Centennial Coal

Western Coal Services Project Response to EIS Submissions

October 2013

Figure 2 – Land Zoning Springvale Coal Services Site

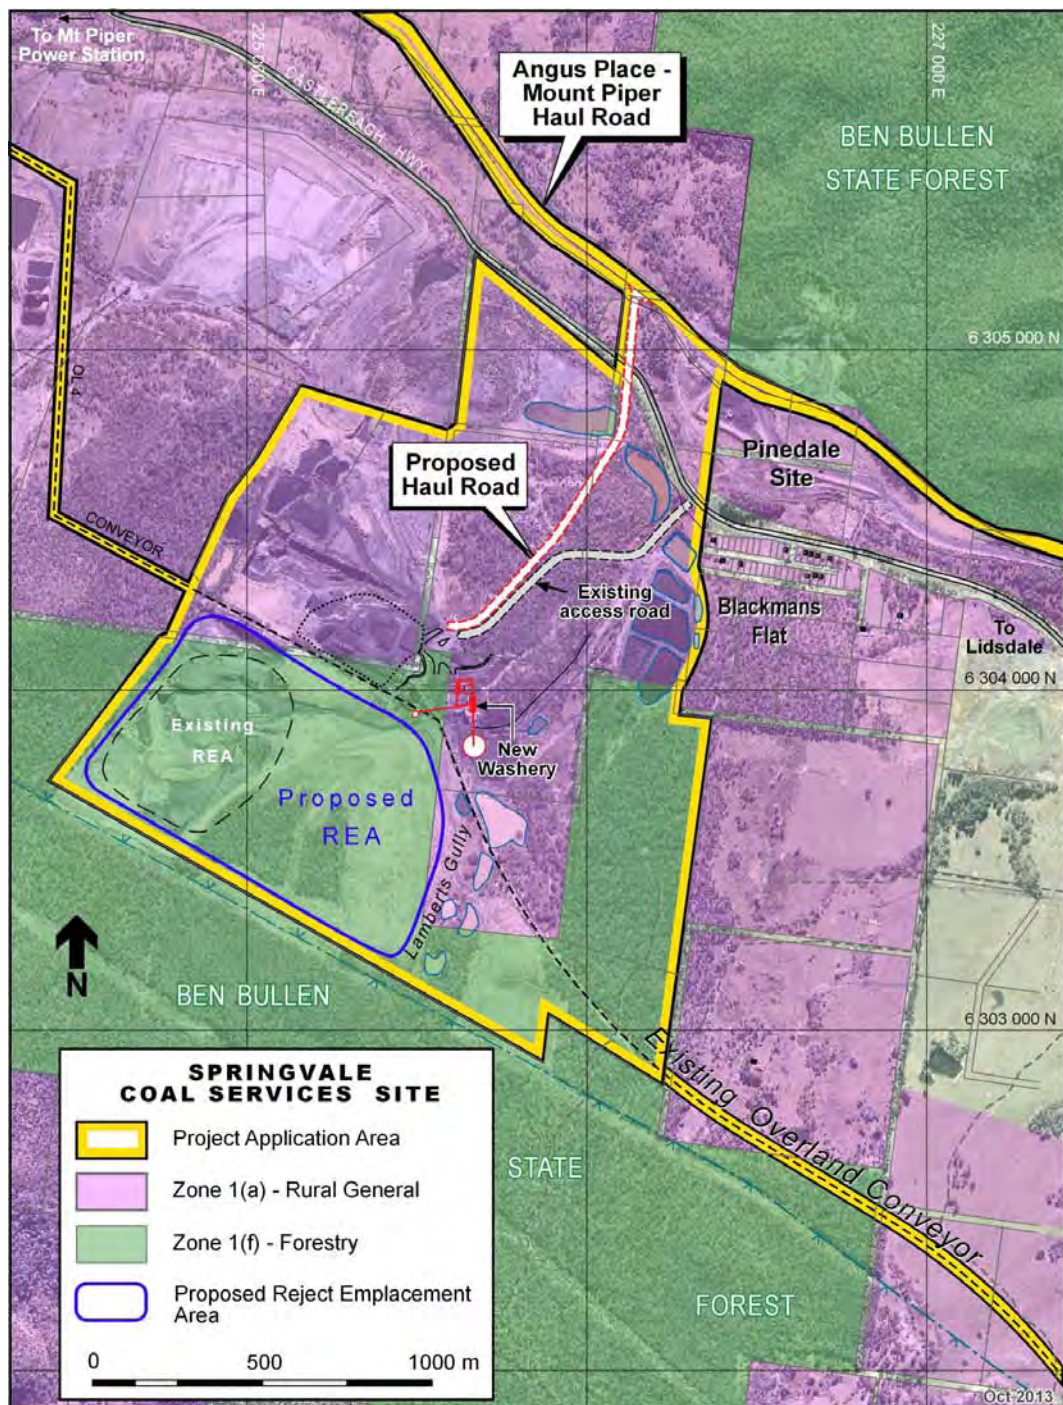
The Department of Planning and Infrastructure requested additional information and clarification during its assessment of the EIS. The additional information provided related to the current land zoning for the Springvale Coal Services Site and the land ownership status of properties in the village of Blackmans Flat. The current land zoning information is shown on Figure 2.

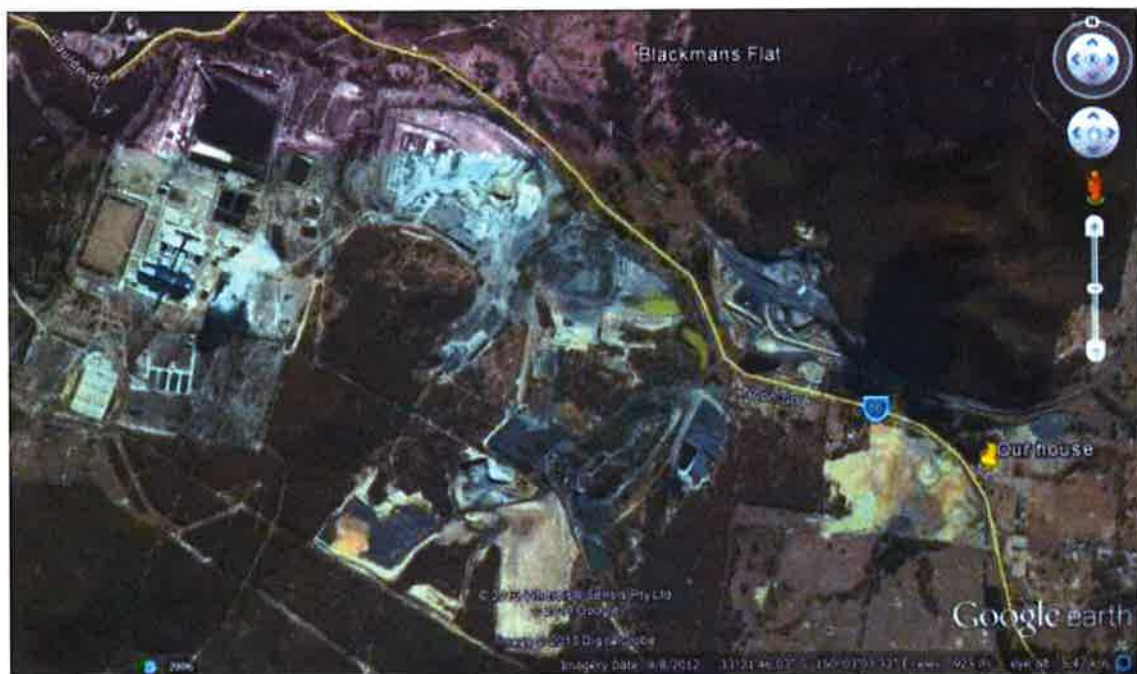
Attached is a snap shot of Blackmans Flat taken in 2006, unfortunately we do not have the opportunity to have access to the real time picture of impacts on the area but believe you would have that opportunity to view. As you can see given all of those industries and the position of our home and the dominating winds, the contours of the forest gives indication of huge concerns of air quality. I am beyond reading and believing data from any of those companies as questioned this current system given past historic evidence by volunteers that has been proven to show all the

documentation provided by a company given to the department failed on numerous occasions with breaches of both state and federal acts.
